# Rezoning Transportation Analysis

Petition Number: 2021-079

## Revision Log:

Date	Description
08-02-2021	First Review (WB)
08-23-2021	Second Review (WB)

Approximate location of Proposed Pedestrian Access

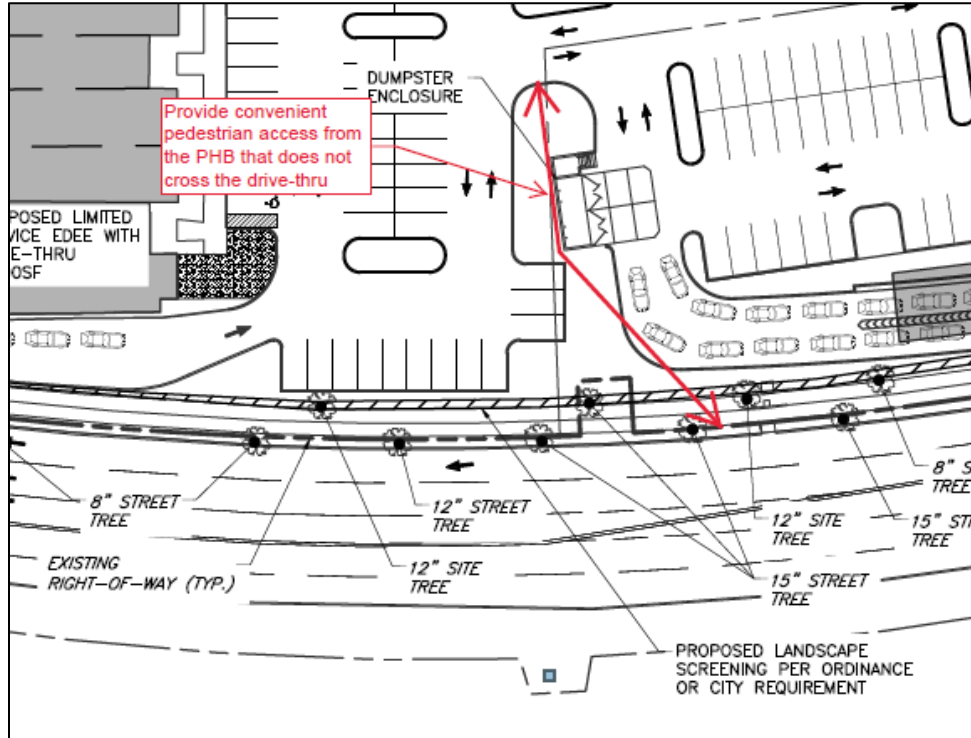
6. Revise site plan and conditional note(s) to commit to provide convenient pedestrian access from the PHB into the site without crossing the drive thru.
